Addendum #03

Date: July 14, 2021

Project: Huntington Middle School Modernization and Addition

DWG. #: **ADM-006**
JOB #: 21938.00
DRAWN BY: TP
DATE: 07/14/21
REF. DOC.: ADDENDUM 03

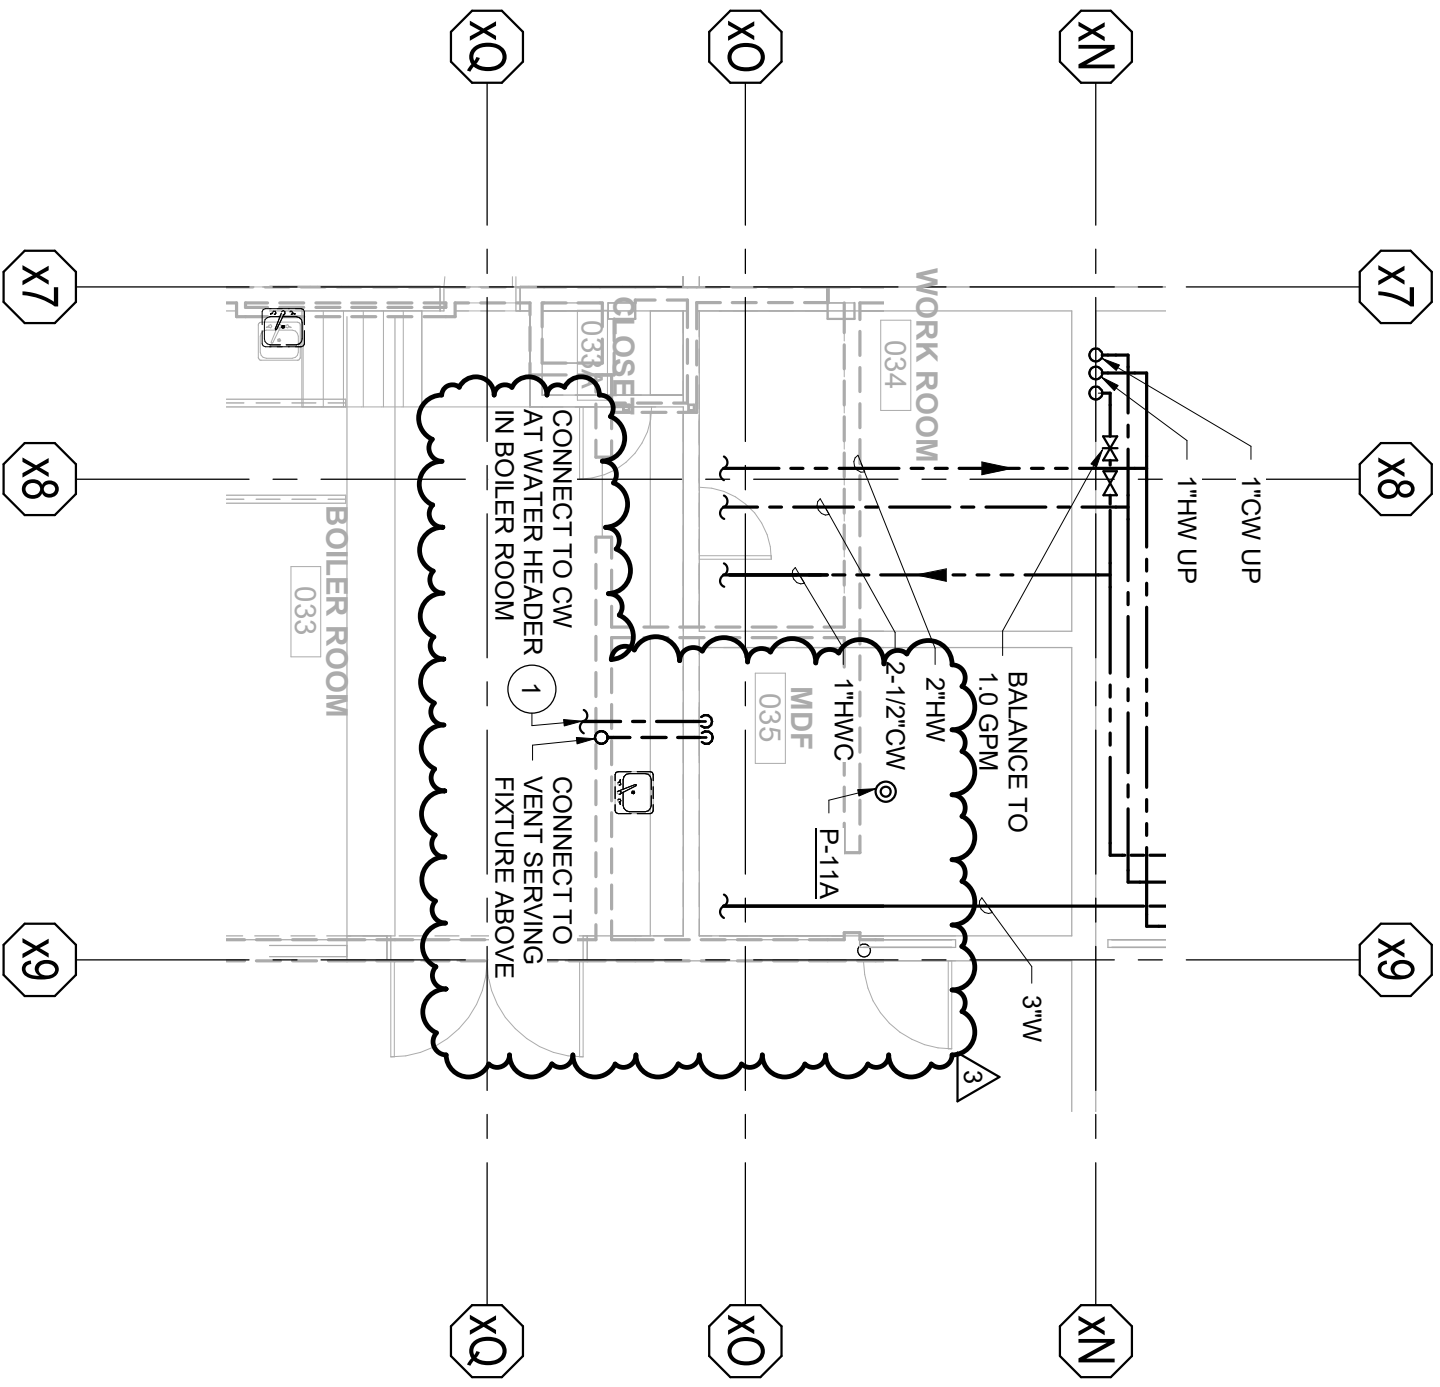
Item #M01 M200A – BUILDING 1 AREA A - FOUNDATION PLAN - PLUMBING

Add. #03 **Revise** per sketch **ADM-006**.

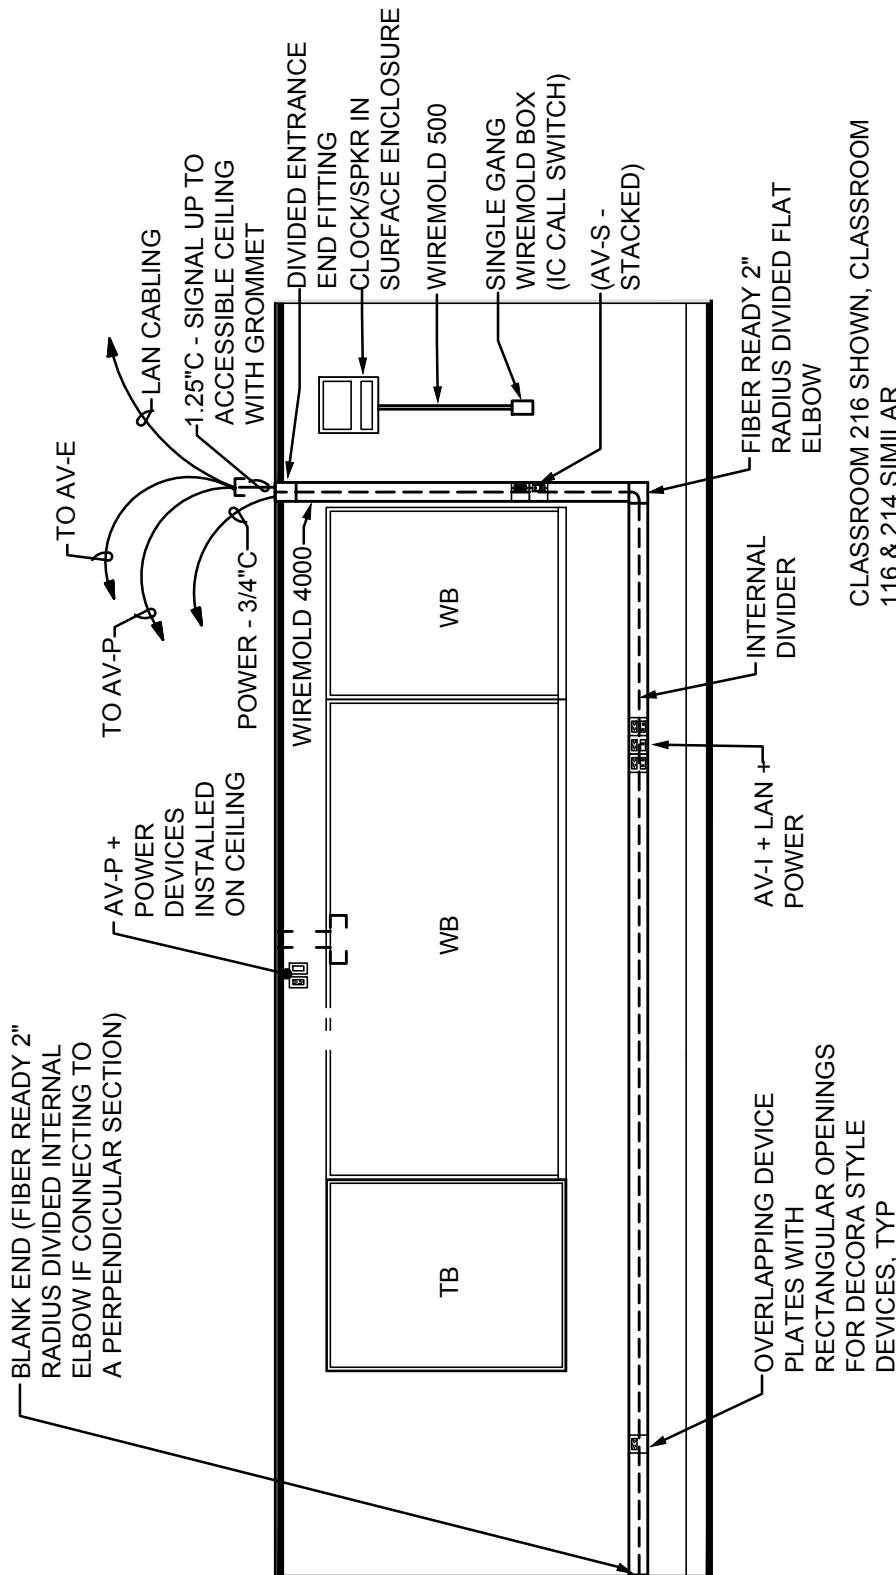
Add. #03 **Revise** Bubble Note 25 to read: “CONCRETE WALL, MOUNT DEVICES IN WIREMOLD 4000, SEE DETAIL 8/E701.” Note, detail to be added per attached sketch **ADE-006**.

Revise AV-I input plate shown on Island in Science Classroom 116 to be located in SMR on south wall and **add** additional length of SMR as shown, see 8/E701.

Revise AV-I input plate shown on Island in Science Classroom 216 to be located in SMR on south wall and **add** additional length of SMR as shown, see 8/E701.
